JLS Conversion to Improved Technical Specifications Diablo Canyon Power Plant

Docket # 50-273
Accession # 9706230042
Date 6/2/97 of Ltr
Regulatory Docket File

CTS 1.0 - Definitions

ITS 1.0 - Use and Application

FIGURE 3.2 3a
RCS TOTAL FLOWRATE VERSUS R(UNIT 1)

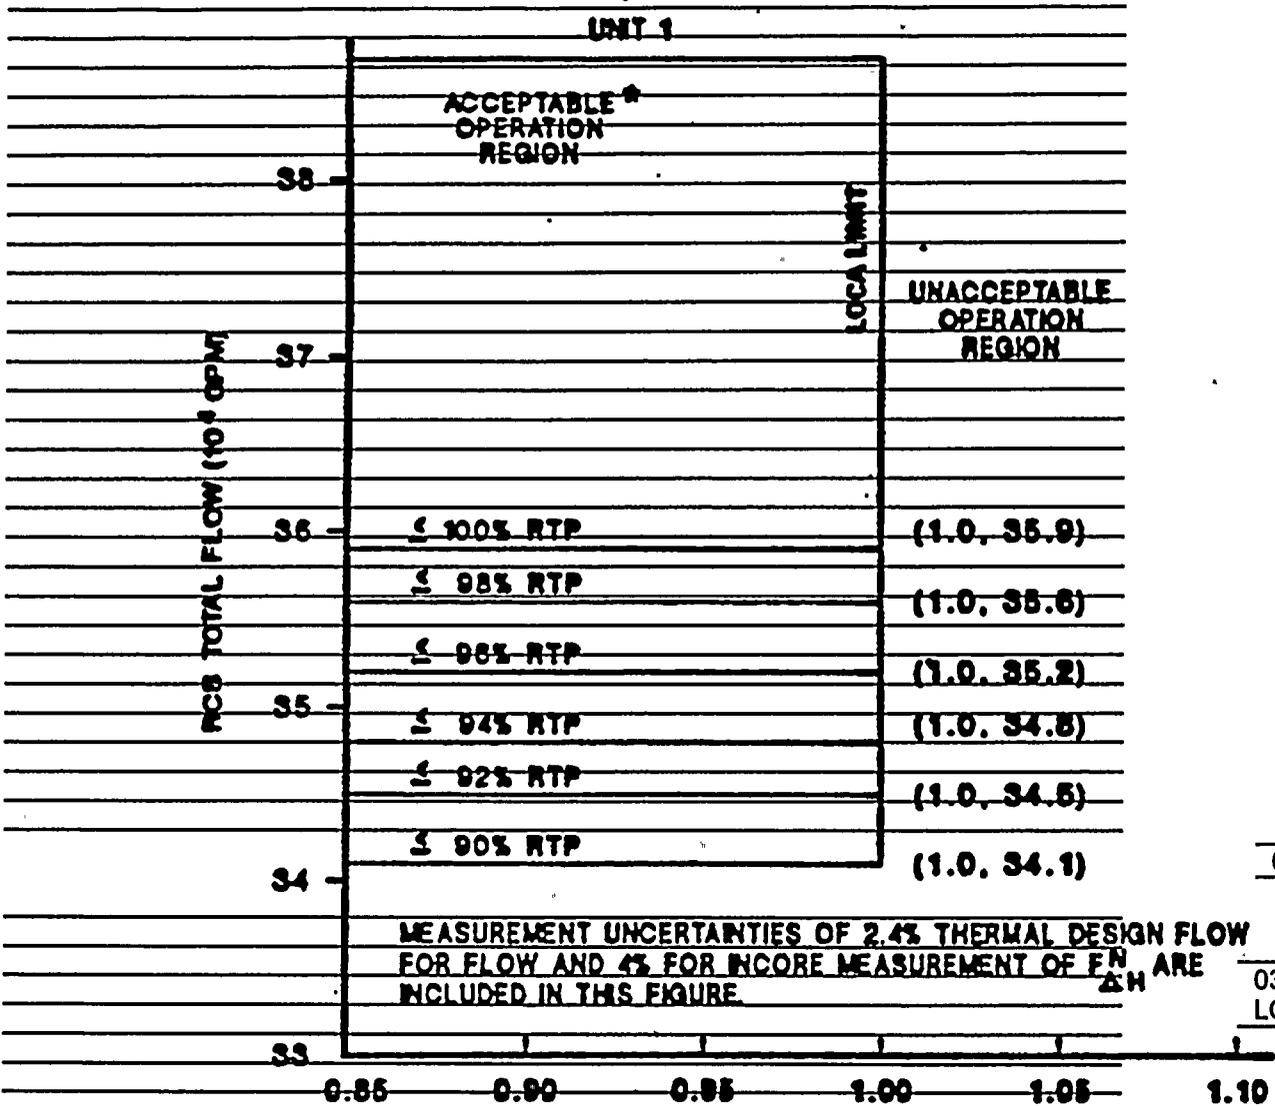
This is an administrative change since the limit for R in Figures 3.2-3a and 3.2-3b is a constant value (1.00); therefore, the equation deriving the Parameter R can be reduced and shown in terms of $F_{\Delta H}^N$.

Figures 3.2-3a and 3.2-3b would be revised to display only parameters RCS flow and power level in tables. The tables show required reduction in power level to account for reduced RCS total flow. The parameter R would be deleted since it is a constant value. This is an administrative change since the only change is in the presentation of these figures.

Figure B 3.2.3B-1 (page 1 of 1)
AXIAL FLUX DIFFERENCE Acceptable Operation Limits
as a Function of RATED THERMAL POWER

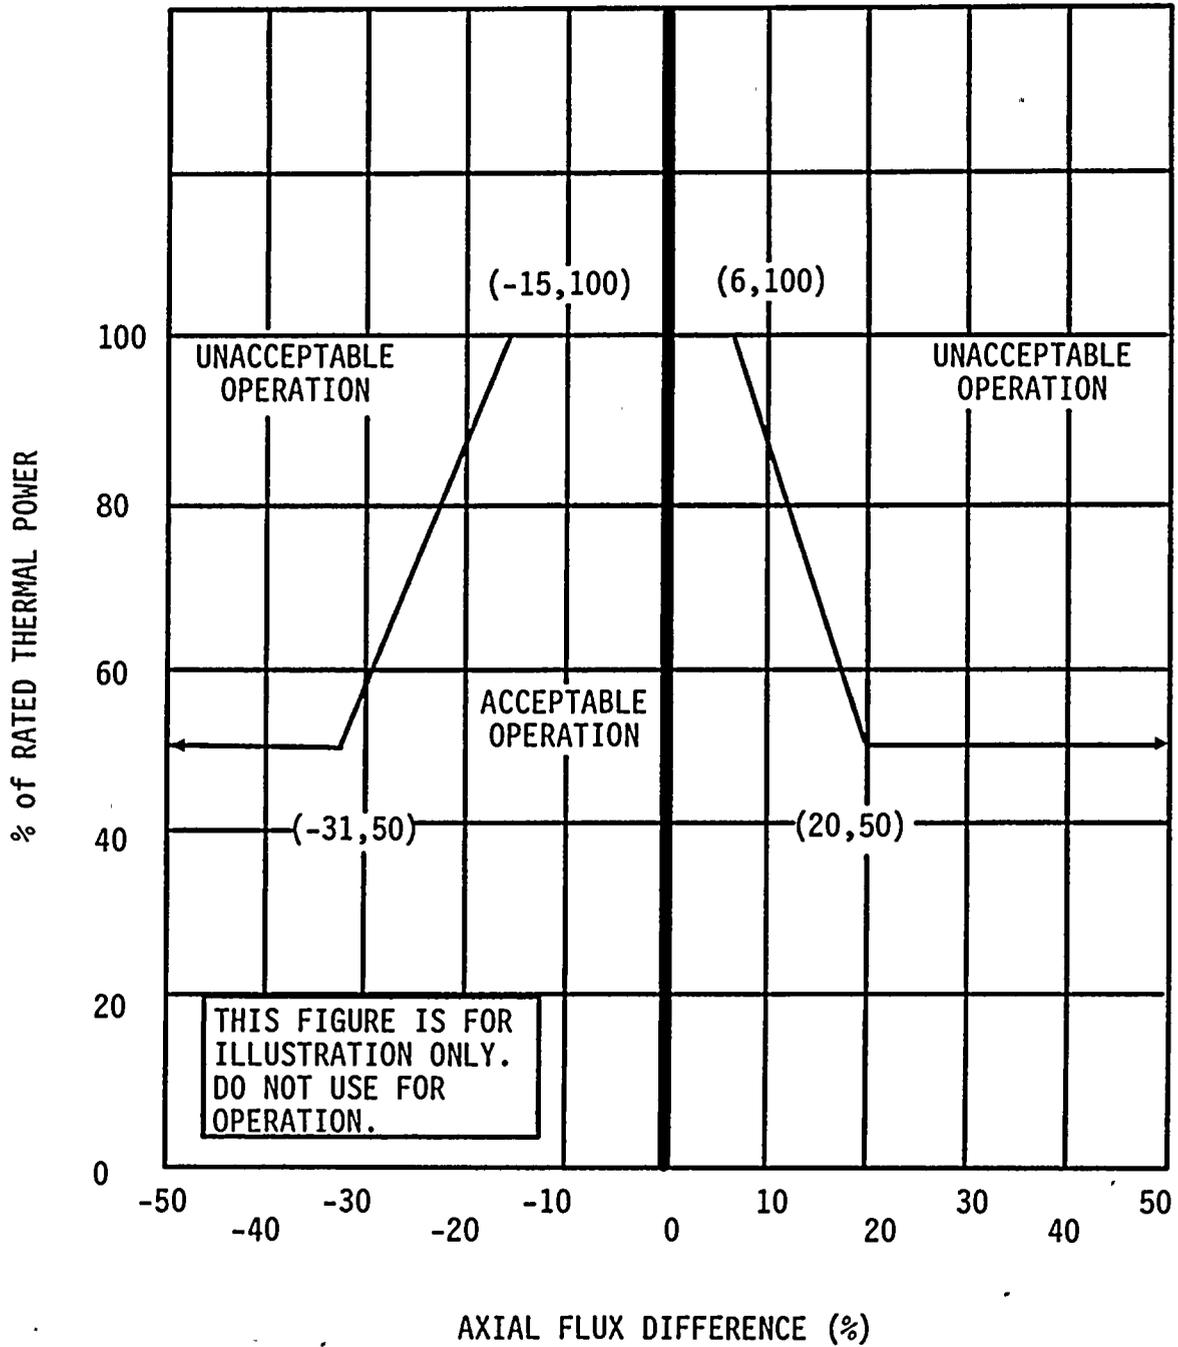
The AFD limits are provided in the COLR. -
~~Figure B 3.2.3B 1 shows typical RAOC AFD limits.~~ The AFD limits for RAOC do not depend on the target flux difference. However, the target flux difference AFD may be used to minimize changes in the axial power distribution.

FIGURE 3.9-1 UNITS 1 AND 2 SPENT FUEL POOL LAYOUT

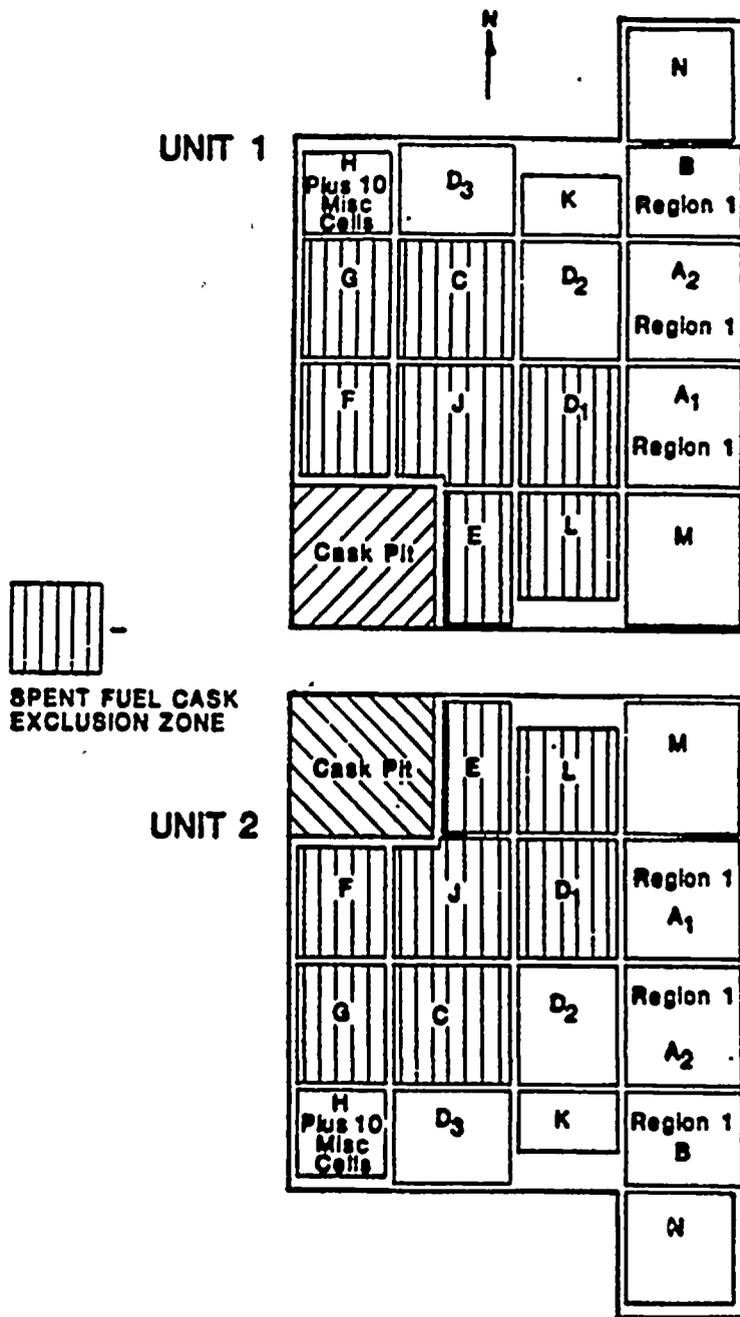
~~3.9.13 No spent fuel shipping cask handling operation near the spent fuel pool (i.e., any movement of a cask located north of column line 12.9 for Unit 1 or south of column line 23.1 for Unit 2) shall be performed with fuel in the spent fuel cask exclusion zone identified in Figure 3.9.1.~~

~~With the requirements of the above specification not satisfied, move the cask out of the specified area(s), or move spent fuel from all locations in the racks within the exclusion zone identified in Figure 3.9.1.~~

~~4.9.13 Racks within the exclusion zone identified in Figure 3.9.1 shall be verified to contain no fuel prior to the movement of the cask into the specified area.~~

FIGURE 5.1-1
EXCLUSION AREA

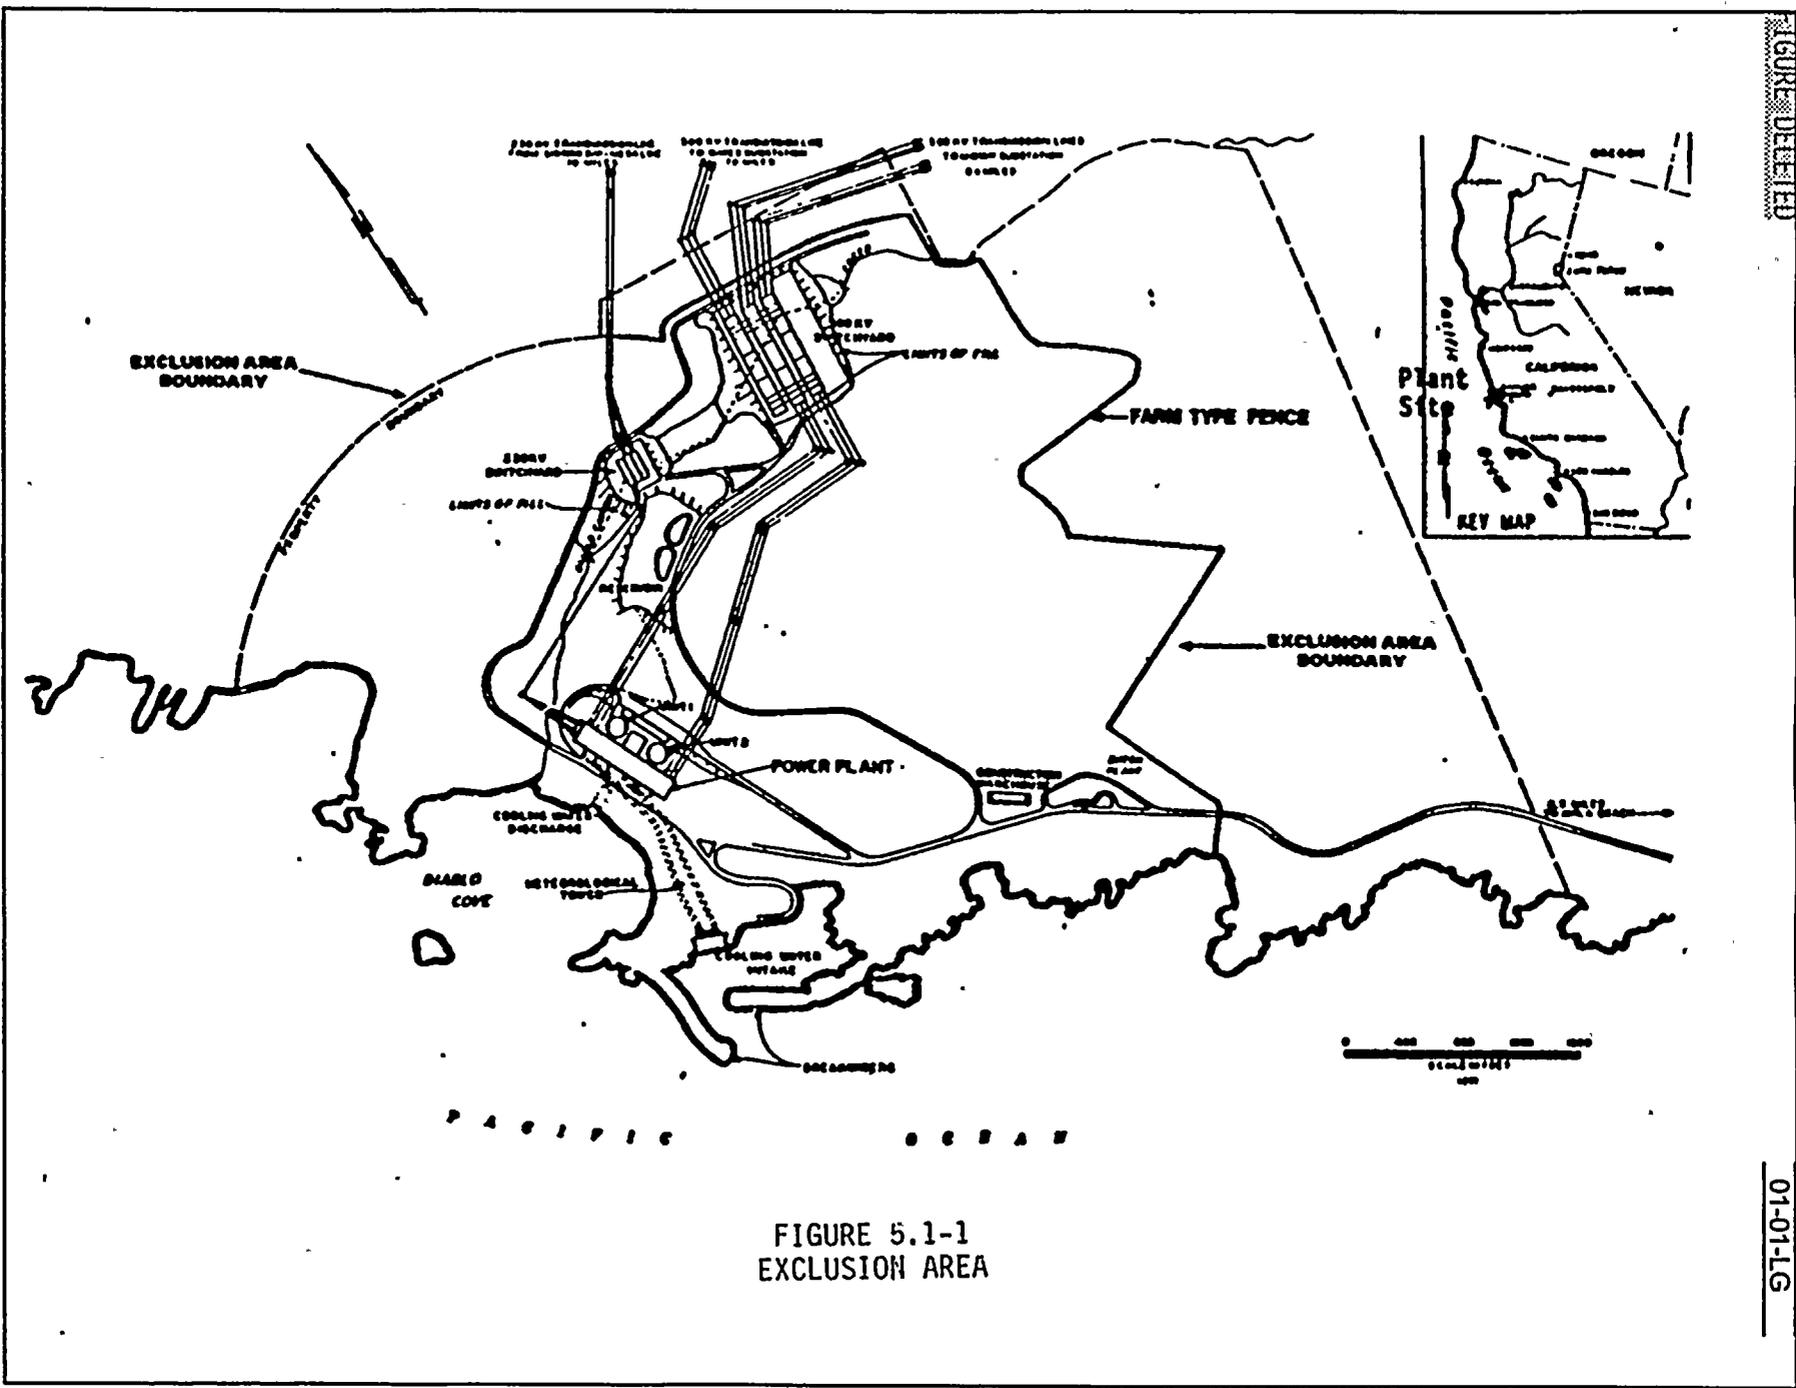
~~5.1.1 The Exclusion Area shall be as shown in Figure 5.1 1.~~

FIGURE 5.1-2
LOW POPULATION ZONE

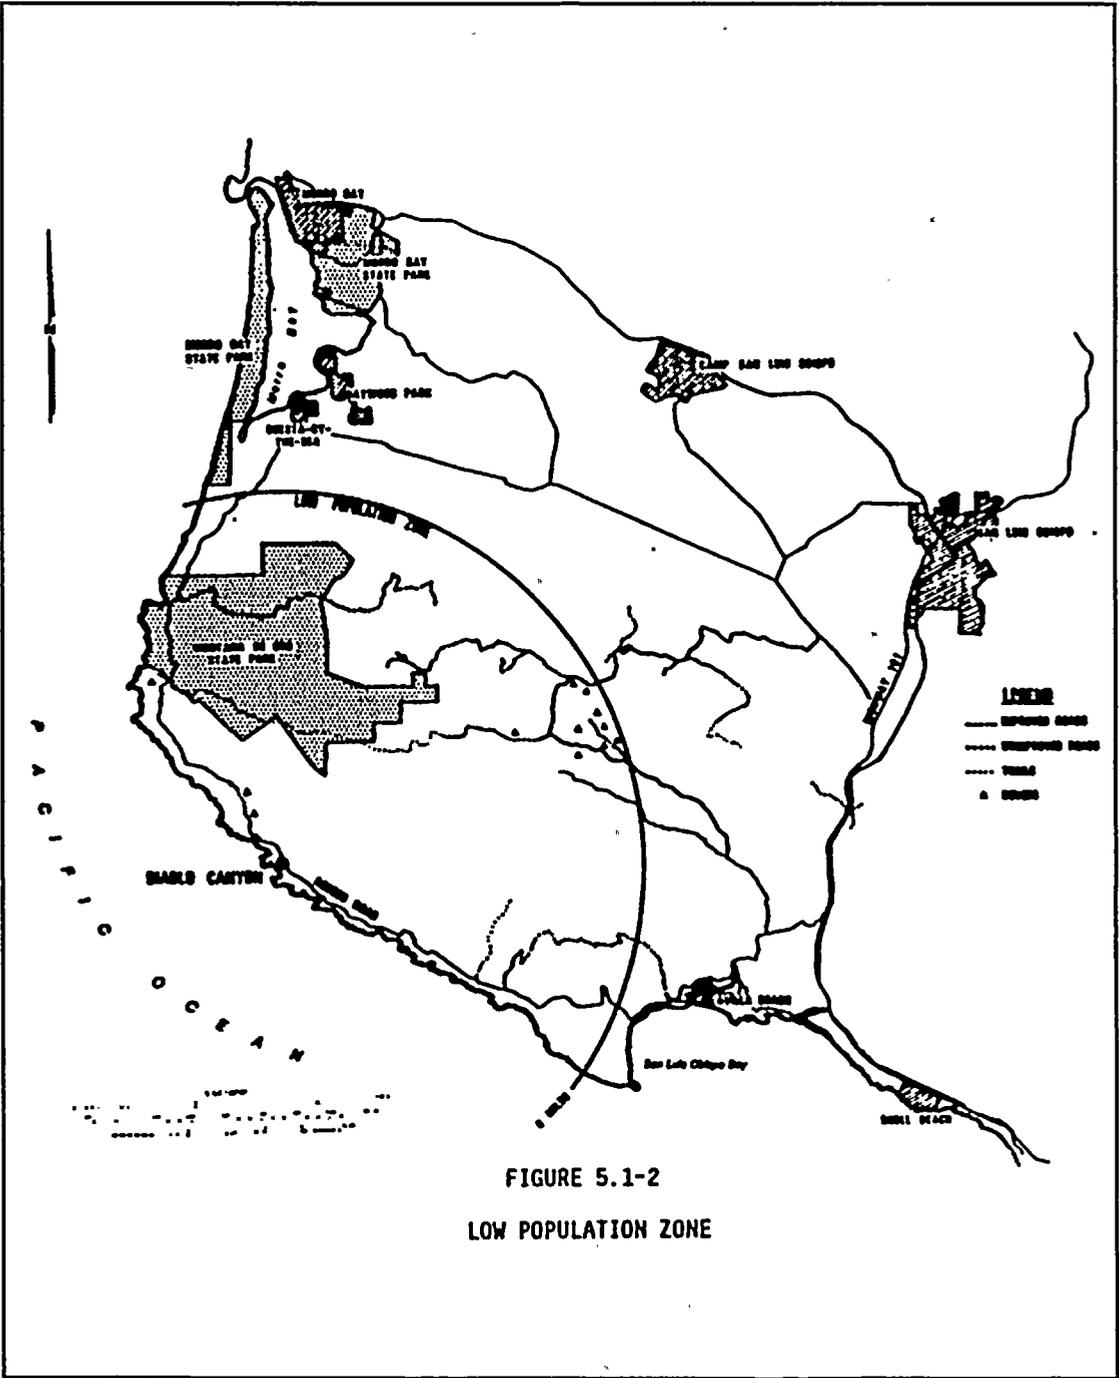
~~5.1.2 The Low Population Zone shall be as shown in Figure 5.1 2.~~

FIGURE 5.1-3
MAP DEFINING UNRESTRICTED AREAS AND SITE BOUNDARY
FOR RADIOACTIVE GASES AND LIQUID EFFLUENTS

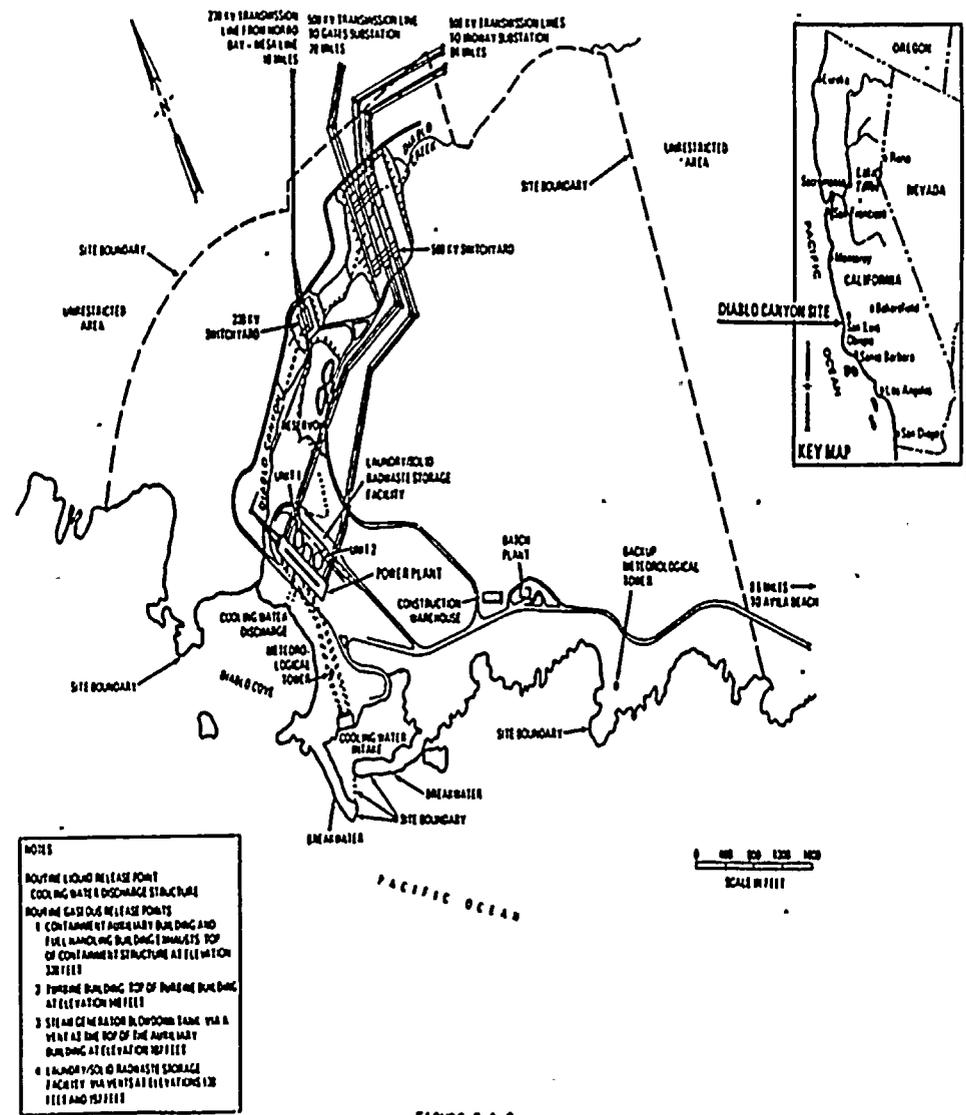
~~5.1.3 Information regarding radioactive gaseous and liquid effluents, which will allow identification of structures and release points as well as definition of UNRESTRICTED AREAS within the SITE BOUNDARY that are accessible to MEMBERS OF THE PUBLIC, shall be as shown in Figure 5.1 3.~~
